Project: Immersion HQ Relocate

Bulletin No.: 1

Bulletin

Bulletin No. 1 incorporates the following revisions to the scope of work as directed by the San Jose Plan Checker and Owner:

44 Existing Stairs and New Accessible Ramp - Main Building Entry
3/16" = 1'-0"

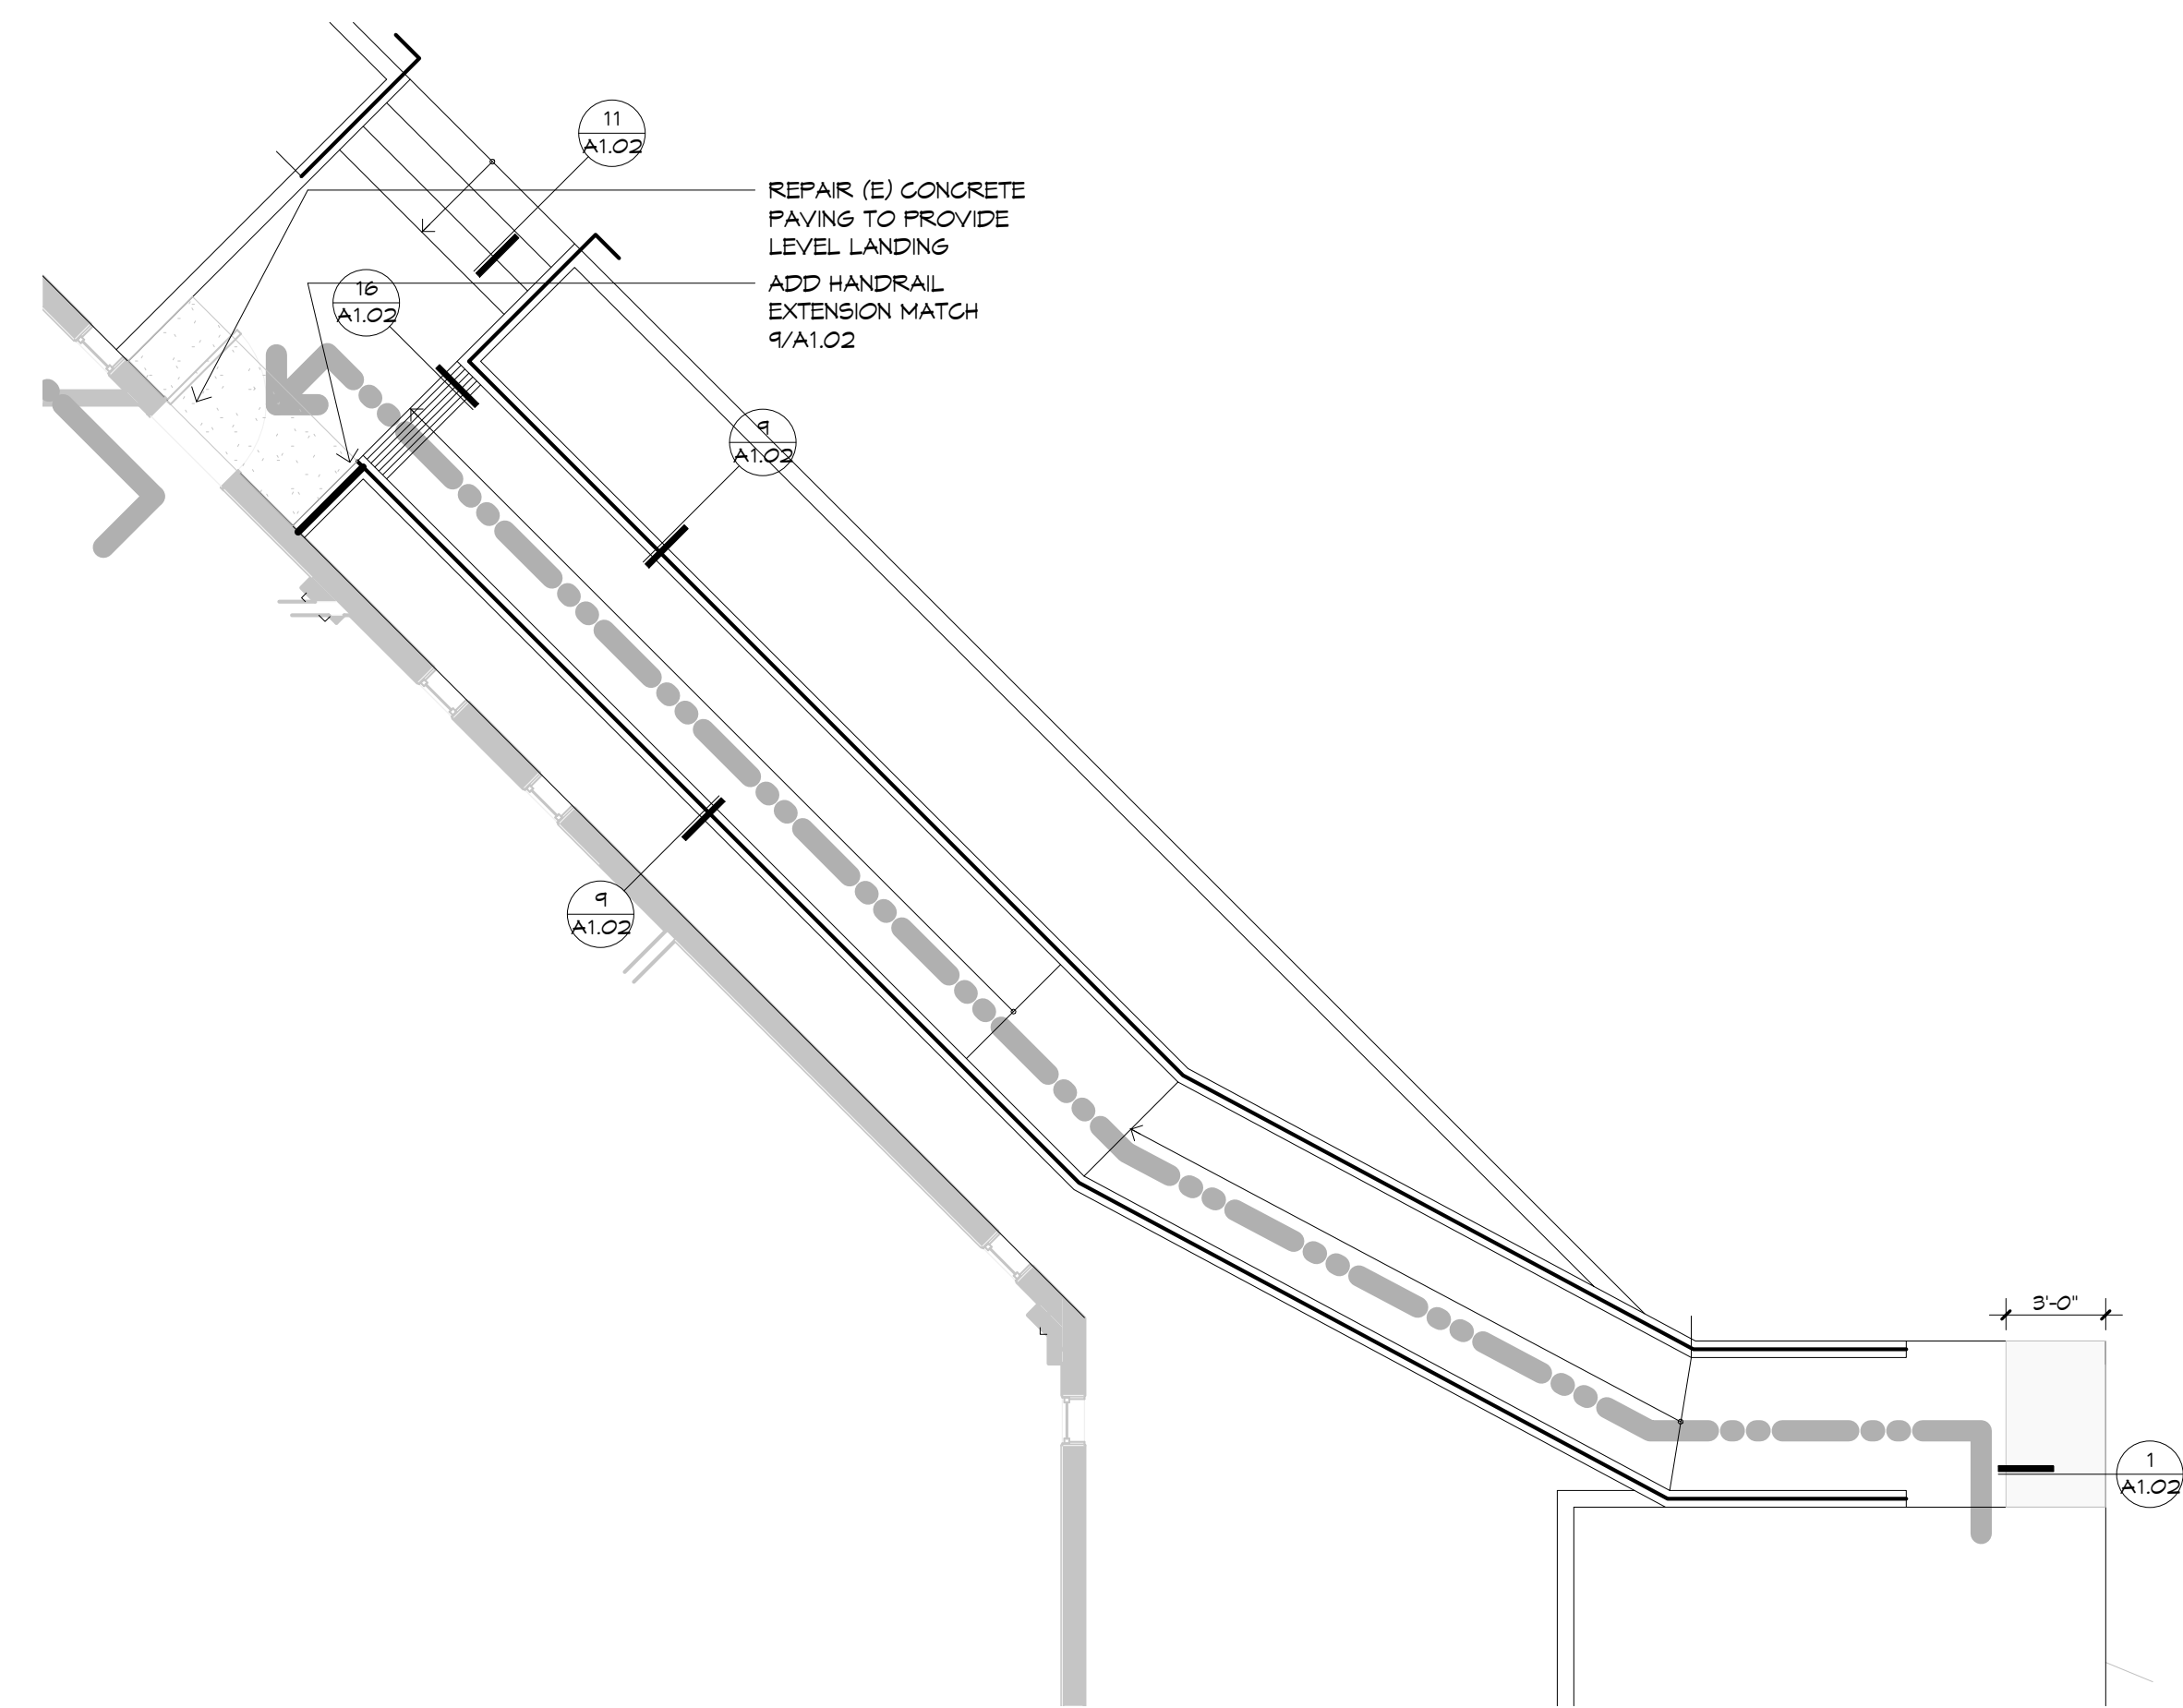
Item 3: Adjust (N) stair rail location at main entry stair.

CONSTRUCTION PLAN - GROUND LEVEL

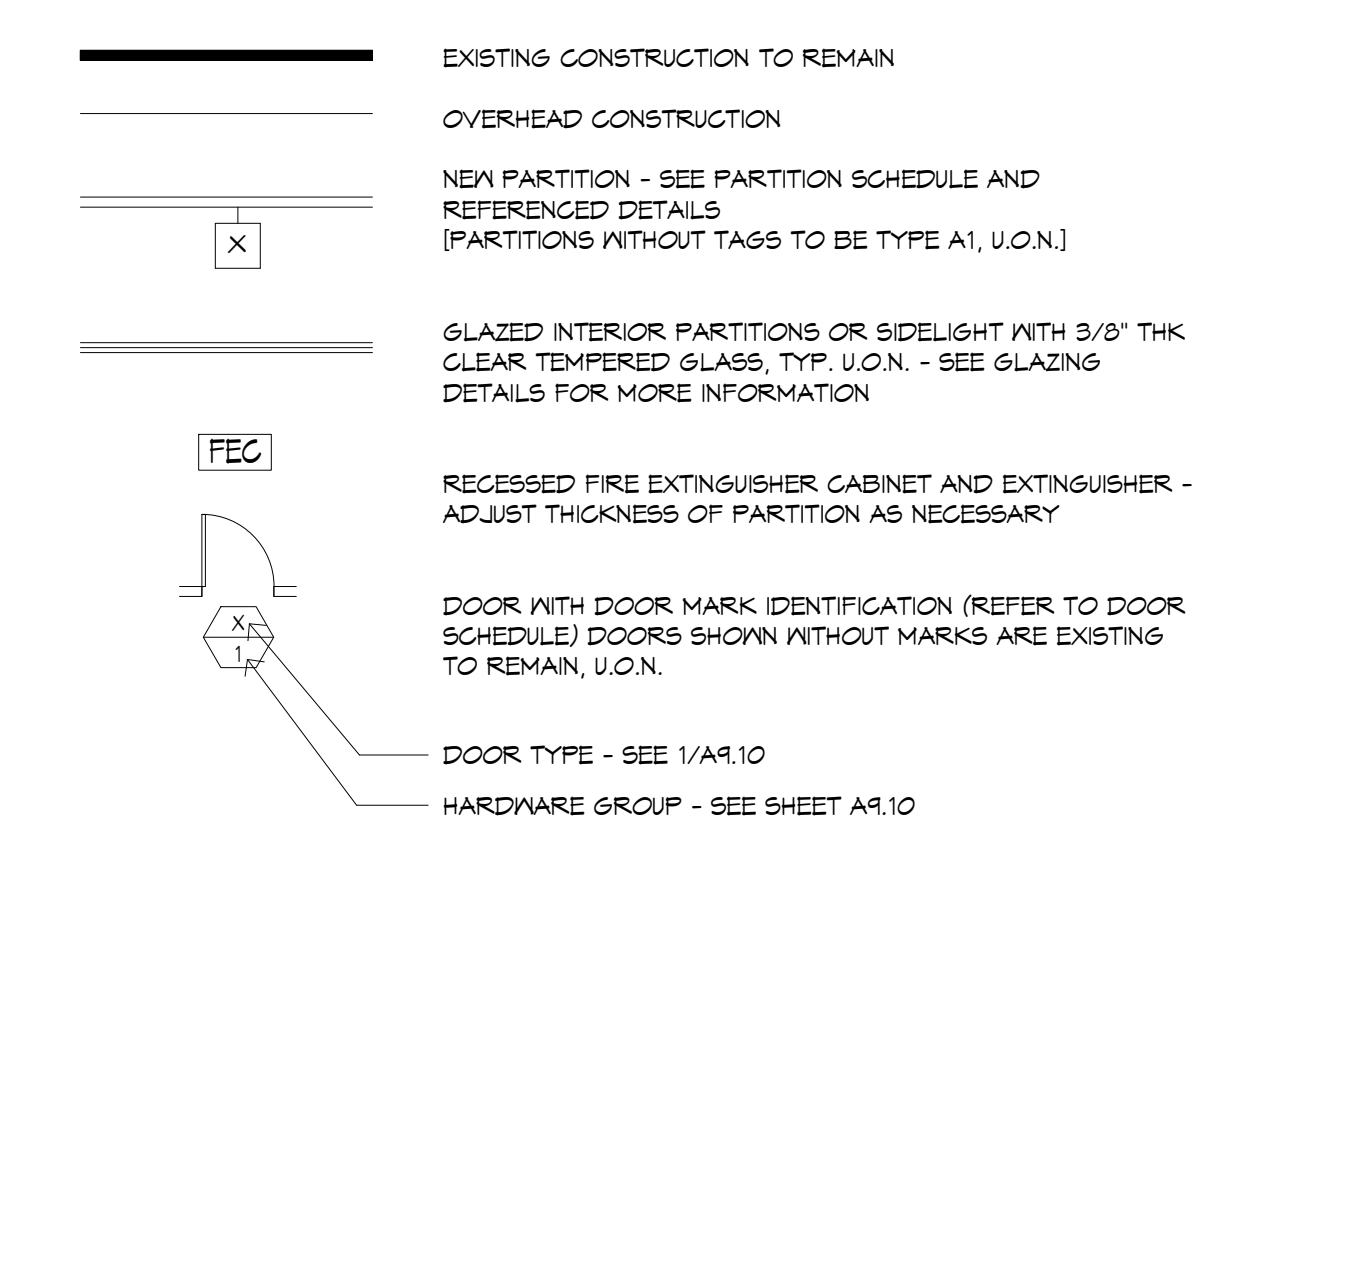
Item 2: Upgrade (E) partitions to 1 hour and doors/frames to 45 min. at Storage #111 and Workshop #112 locations.

Item 4: Demolish (E) water heater closet at Men's Toilet Room, replace (E) water heater in Mech. Room and renovate piping to serve devices previously served by water heater in closet at Men's Toilet Room.

- (KEY NOTES FOR THIS SHEET ONLY)
- REMOVE (E) CARPET THIS ROOM/AREA, SALVAGE FOR REINSTALLATION AS DIRECTED. SEE FINISH PLAN.
 - (N) BLDG STD. SIDELIGHT
 - NEW TACTILE ENTRANCE SIGN
 - UPGRADE (E) PARTITION TO MATCH PARTITION TYPE B-2
 - VIF (E) DOORS/FRAMES ARE RATED 45 MIN., UPGRADE TO 45 IN DOORS/FRAMES IF NECESSARY.
 - PROVIDE (N) DOUBLE-PANED LOW E GLAZING IN ALUMINUM FRAMES TO MATCH (E) BASE BUILDING EXTERIOR GLAZING FRAME SYSTEM, PROVIDE BLDG STD. WINDOW BLINDS AT INTERIOR.
 - (N) WATER HEATER TO REPLACE (E) SIZE TO ACCOMMODATE (E) CAPACITY PLUS REQUIRED CAPACITY FROM DEMOLISHED WATER HEATER FROM MEN'S TOILET ROOM CLOSET.

12 ALUM. FRAME GLAZING HEAD @ EXTERIOR WALL
6" = 1'-0"

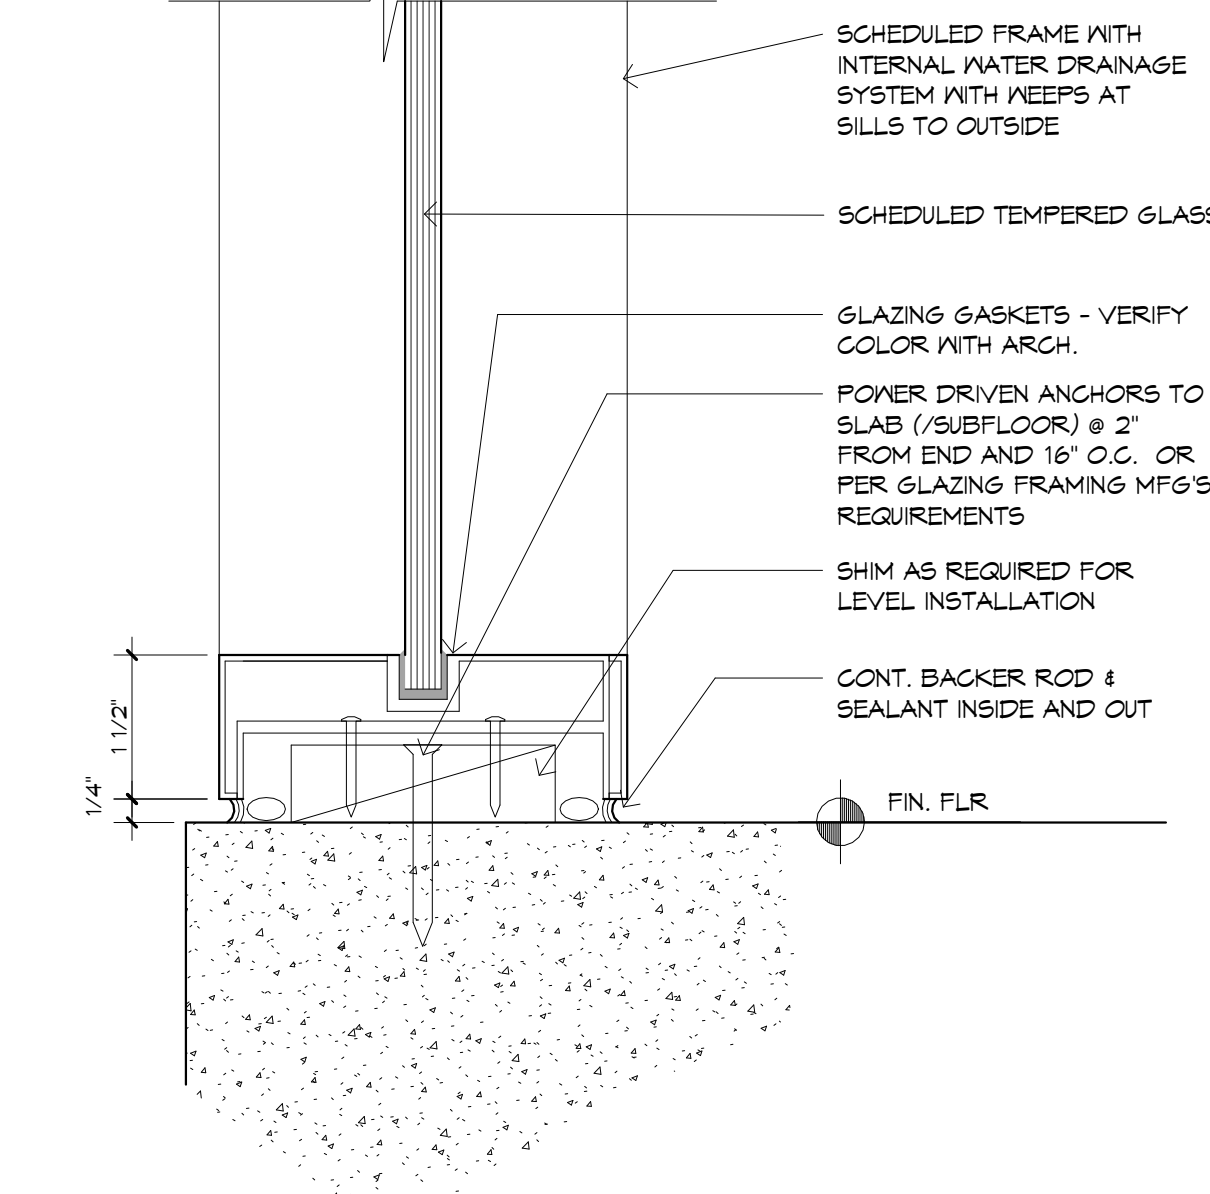
Item 1: Add exterior glazing at two (e) roll-up exterior door locations.
